Project Title: Proposed U.S. District Courthouse

RE: NEW U.S. COURTHOUSE (4th ST. & LOMAS BLVD.) (J-14K/D-120)
ENGINEER'S STAMP DATED 4/23/96

RE: BERNALILLO COUNTY COURTHOUSE (J14-D120). DRAINAGE REPORT AND CONCEPTUAL GRADING AND DRAINAGE PLAN FOR PRELIMINARY PLAT AND SITE DEVELOPMENT PLAN FOR BUILDING PERMIT. ENGINEER'S STAMP DATED 10-13-97.

Map No. 2 - Conceptual Grading and Drainage Plan

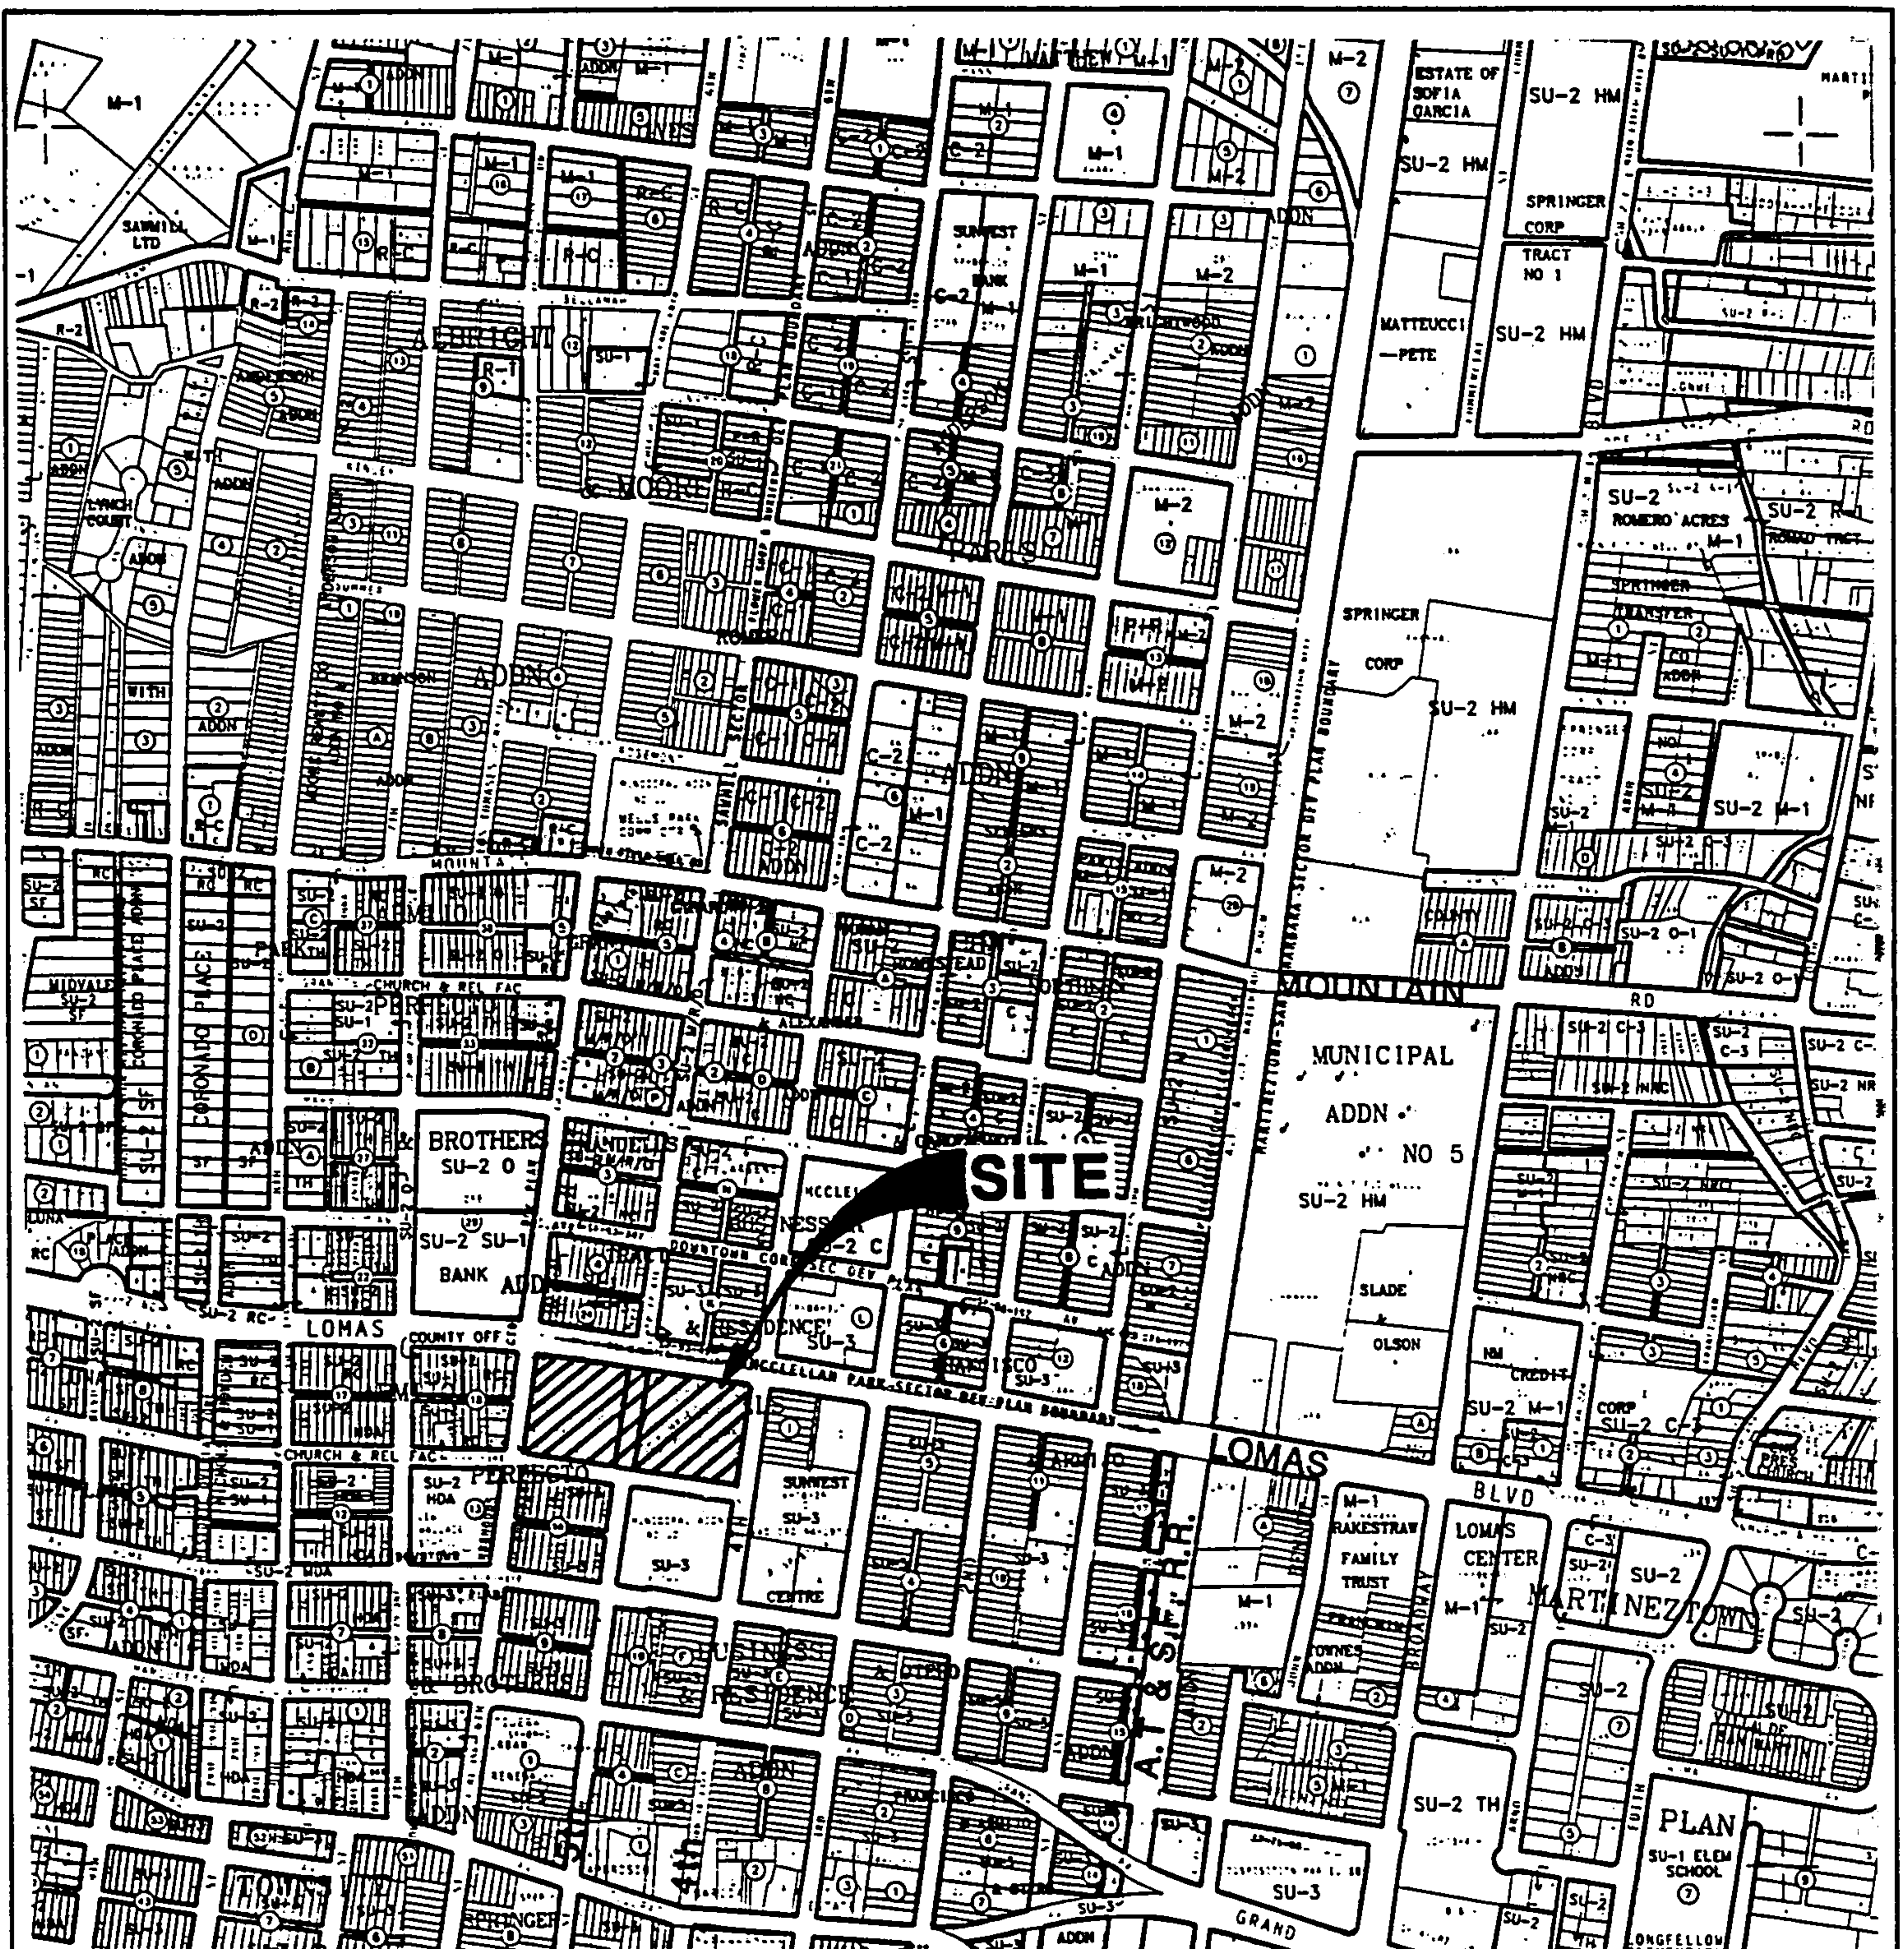
1. A conceptual plan is not adequate for Preliminary Plat approval. Preliminary Plat requires a detailed grading and drainage plan with associated hydrology calculations.

2. Provide inlet and storm drain capacity calculations.
3. Show the storm drain pipe that takes the roof flow to the inlet.
4. Label proposed and existing inlets and manholes on the legend. I am having a difficult time determining what you are installing, and what is existing.
